REGIONAL REVIEW FINDING

ARC REVIEW CODE: R1901071

Name of Proposal: Fort McPherson Redevelopment (DRI 2877)

Review Type: Development of Regional Impact **Date Opened:** Jan. 7, 2019 **Date Closed:** Jan. 22, 2019

GSWCC CERT. LEVEL: B XXXXXXXXXX
DRAWN BY: ZLR
DESIGNED BY: XYZ
REVIEWED BY: PDQ
DATE: 12/21/2018
PROJECT NO: 019779008
TITLE: DRI SITE PLAN (1 OF 2)
SHEET NUMBER: DRI #2877

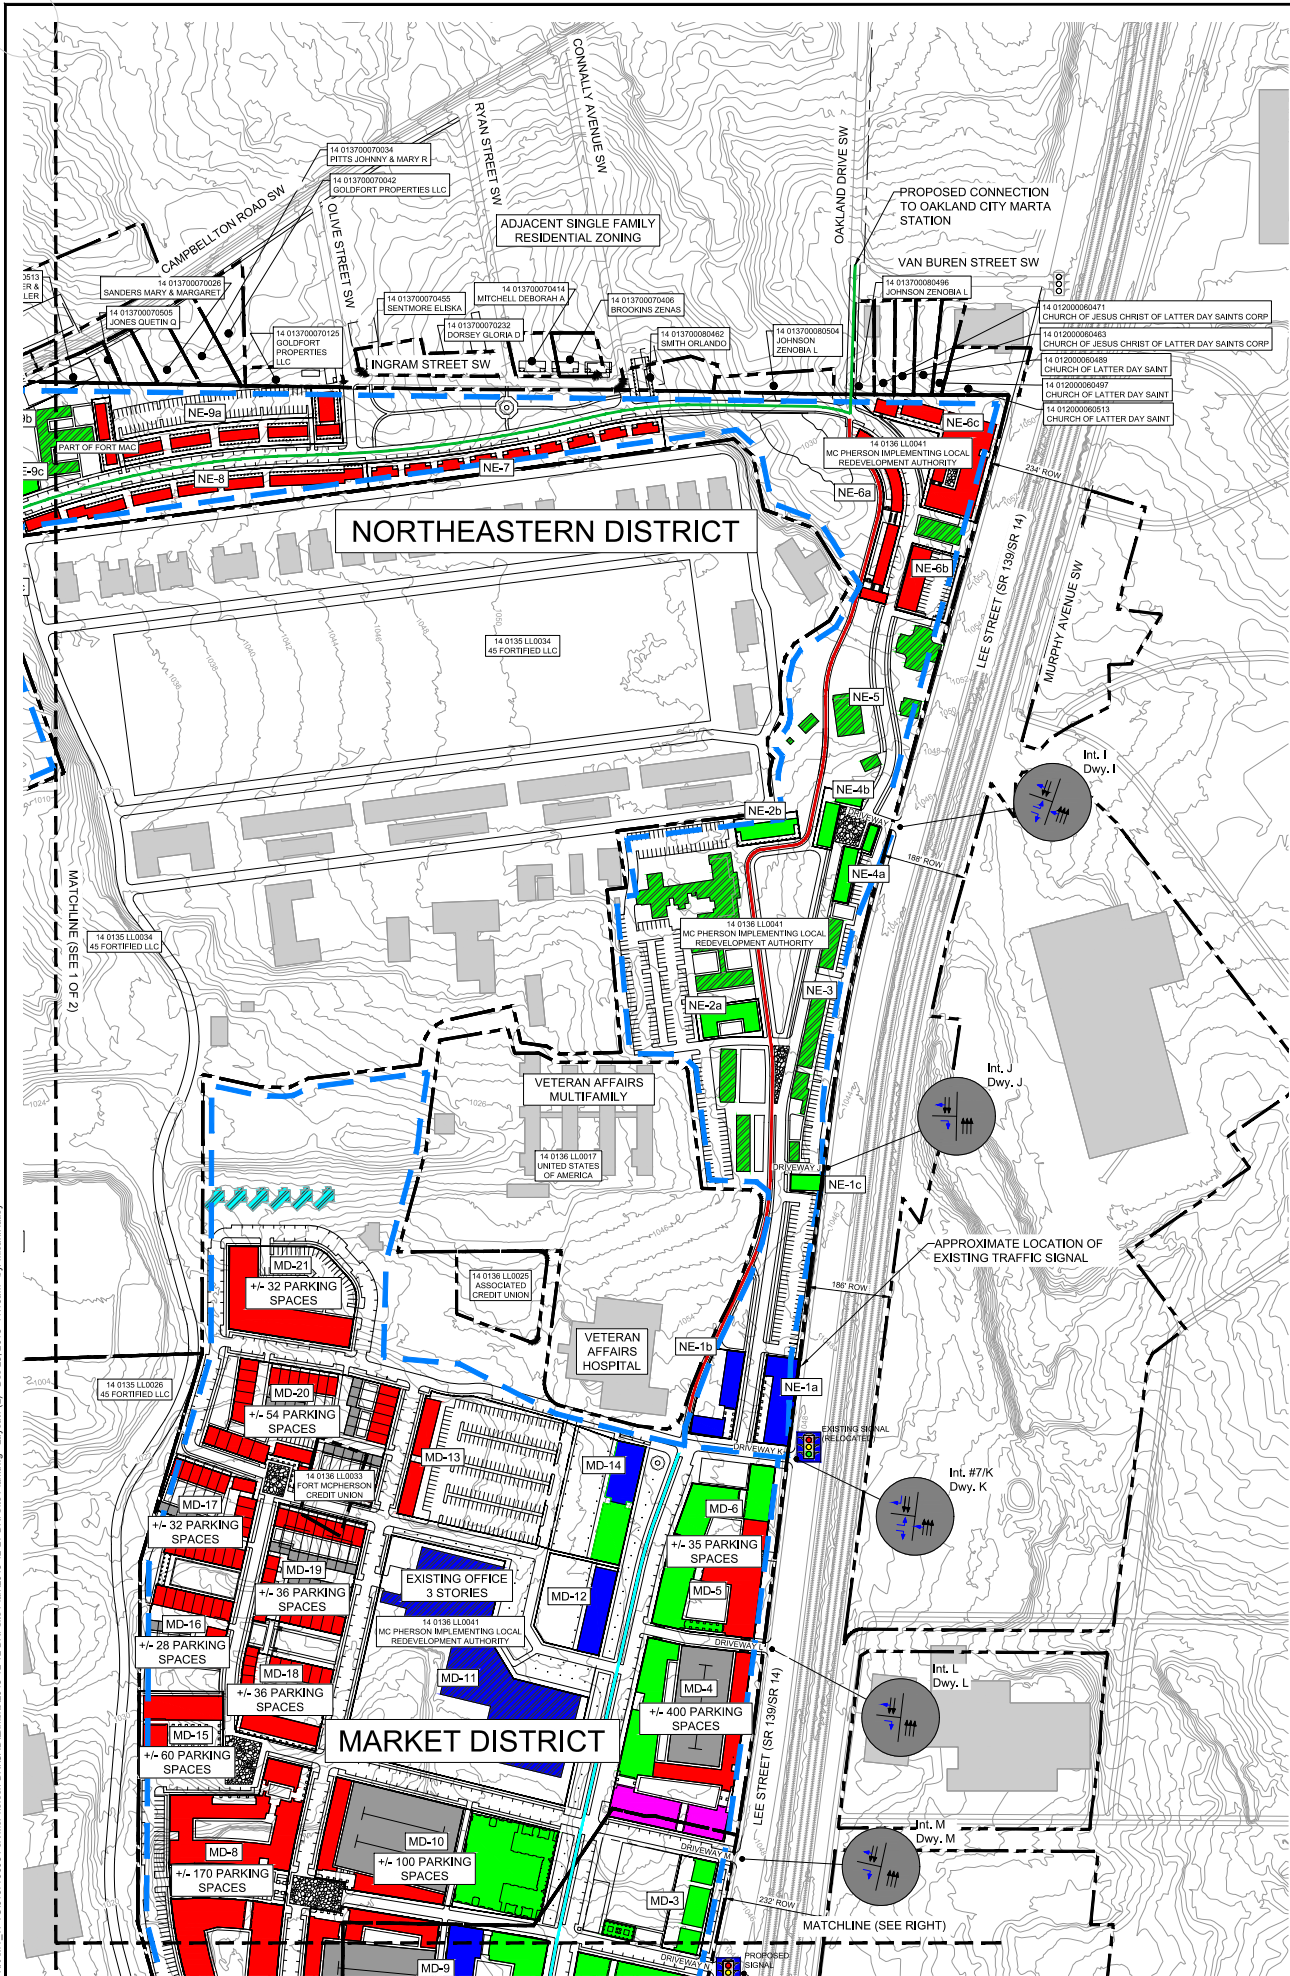
To capitalize on this potential, care should be taken to ensure that the development, as constructed, promotes an interconnected, functional, clearly marked and comfortable pedestrian experience on all streets, paths and parking areas. One note is that at the southern end of the site, the bike-only lane appears to travel from the entry plaza to Driveway O via the right-of-way of an internal drive/parking area.

Ideally, this type of bike facility should be protected from vehicular traffic and parking stalls to prevent bike/car conflicts.
